# Masterplan Peer Review Lakeside Development: Te Kauwhata

Date 11 May 2017

# Masterplan Peer Review

## Lakeside: Te Kauwhata

Diagram 03

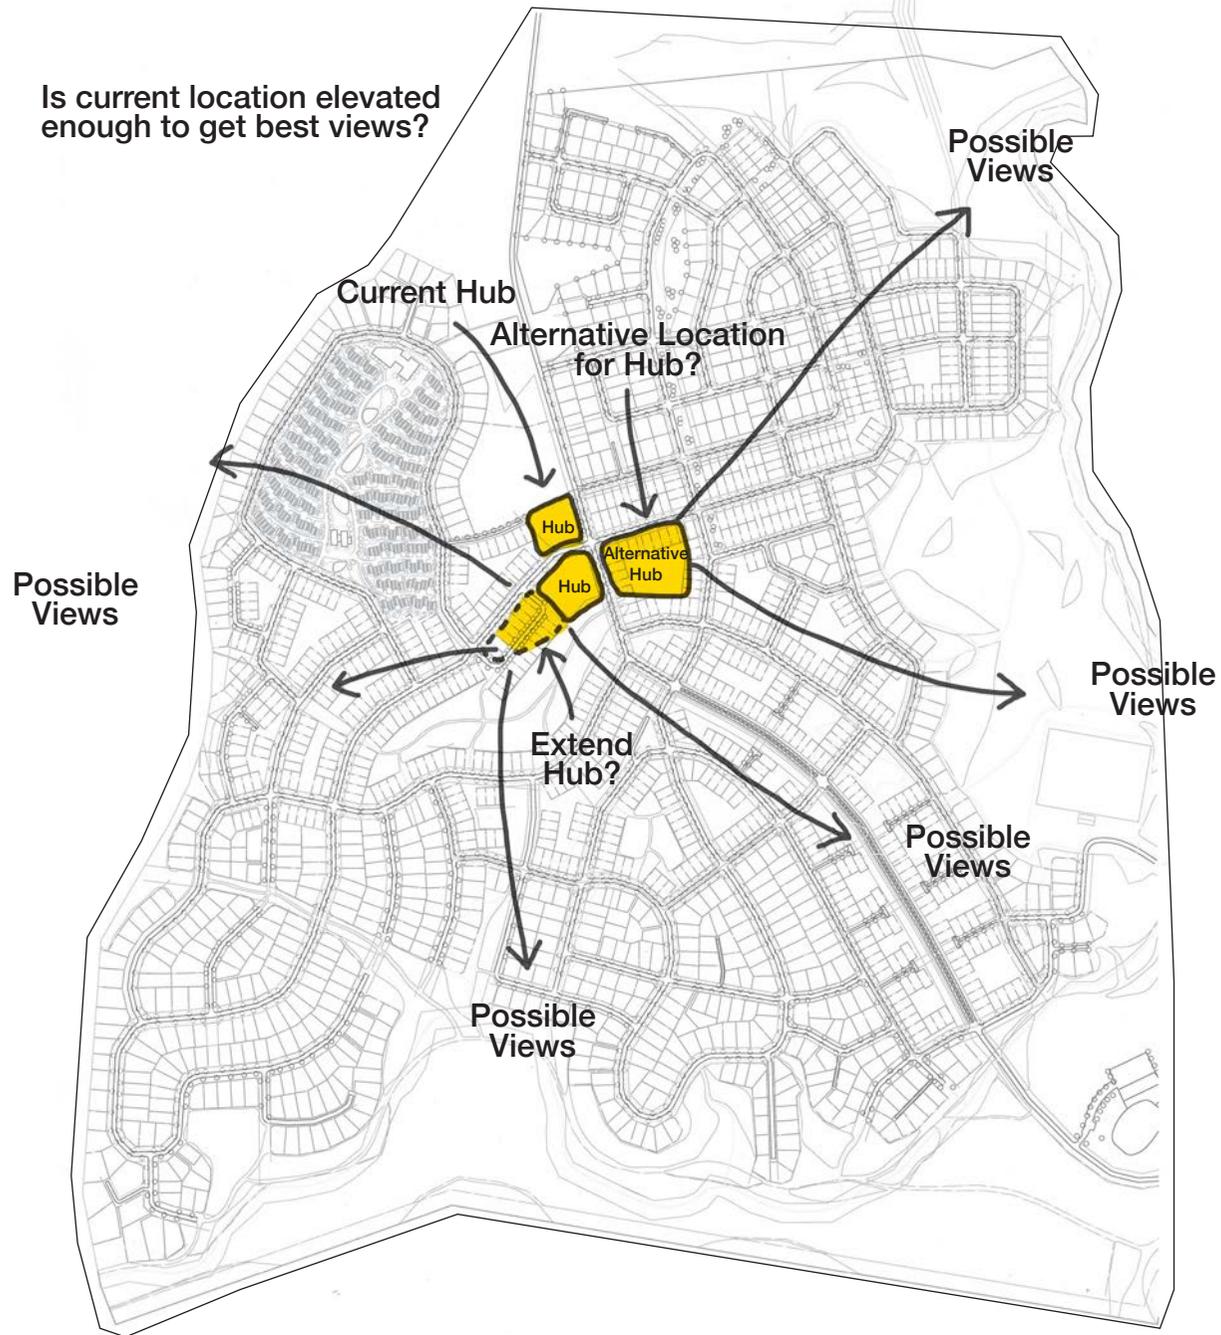
3	<p><b>Configuration and size of pocket parks</b></p> <ul style="list-style-type: none"> <li>• Some of the pocket parks are very large others very small?</li> <li>• There are quite a number of funny residual open spaces.</li> <li>• Could they be better rationalised?</li> <li>• Should the block sizes for the medium density be bigger in some cases?</li> <li>• Refer Diagram 03.</li> </ul>	<ul style="list-style-type: none"> <li>• The pocket parks have been rationalised and simplified.</li> <li>• Smaller residual open spaces have been minimised.</li> <li>• There is greater legibility between pocket parks and linked green spaces.</li> <li>• Larger blocks and simpler spaces have been achieved.</li> </ul>	<ul style="list-style-type: none"> <li>• Outcome achieved, no further comments.</li> </ul>
4	<p><b>Visibility of pocket parks from vested roads (CPTED)</b></p> <ul style="list-style-type: none"> <li>• Typically the pocket park would have at least one if not two road edges for CPTED reasons.</li> <li>• Some pocket parks are bounded on four sides by houses.</li> <li>• Can some of the parks be re-orientated for views and to street edges for safety.</li> <li>• Refer Diagram 03.</li> </ul>	<ul style="list-style-type: none"> <li>• Greater visibility and accessibility to the pocket parks from vested roads has been achieved in most cases.</li> </ul>	<ul style="list-style-type: none"> <li>• Recommend further development to ensure all pocket parks follow sound CPTED principles and have at least one side adjoining a vested road for visibility and safety.</li> </ul>

Diagram 04

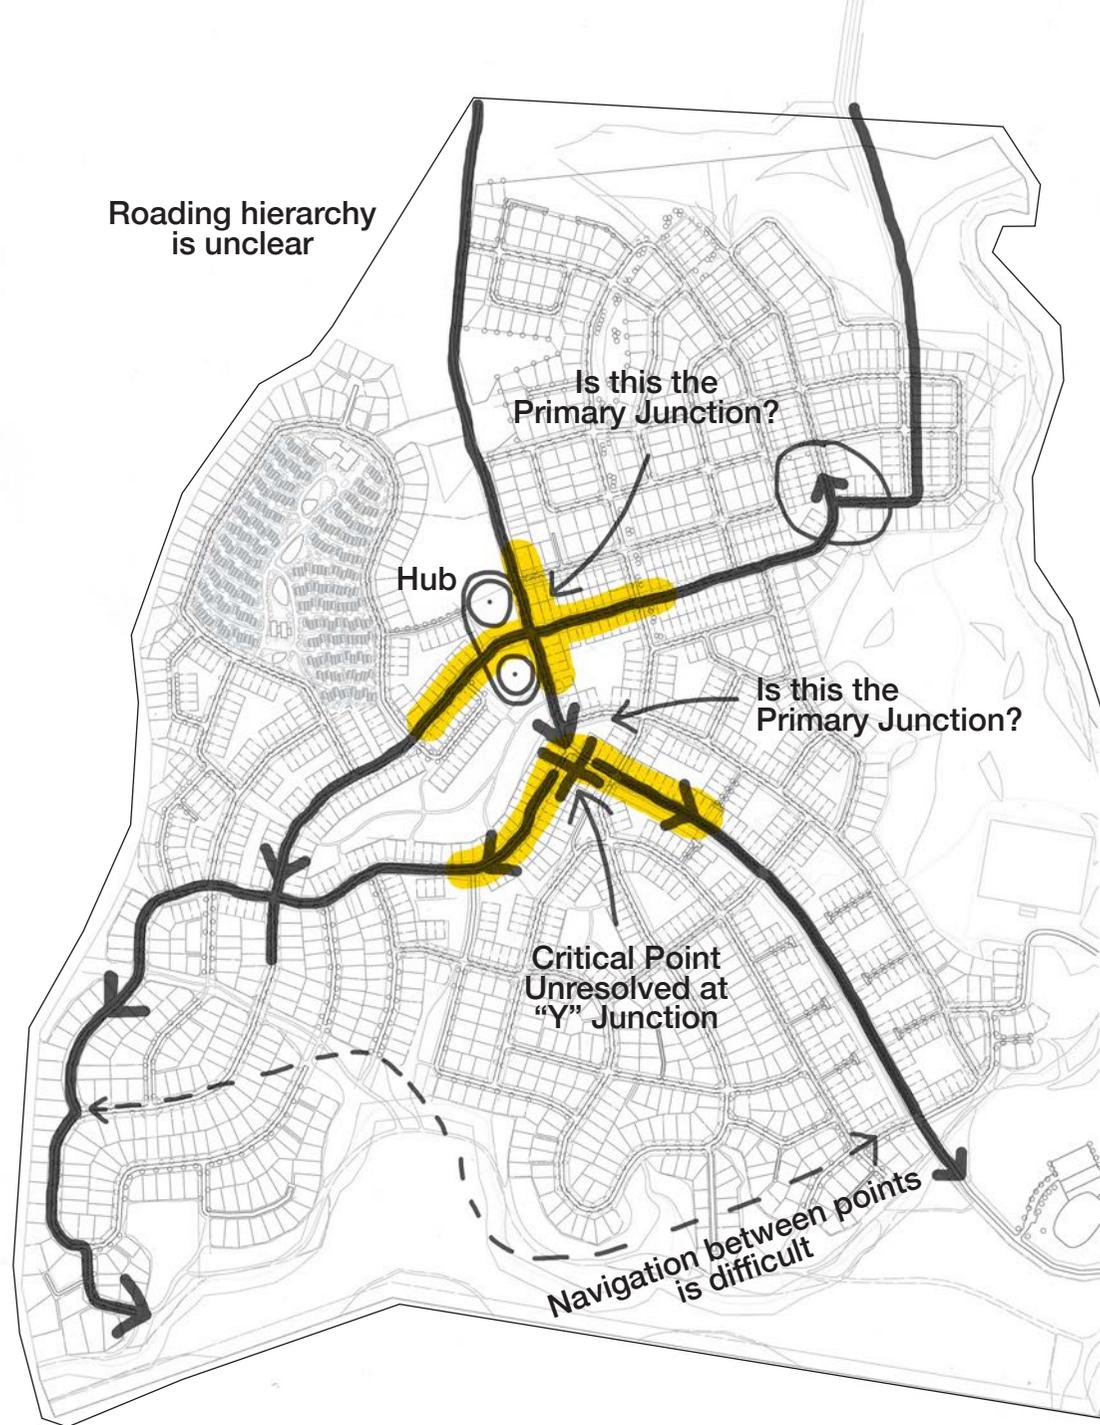
Is current location elevated enough to get best views?
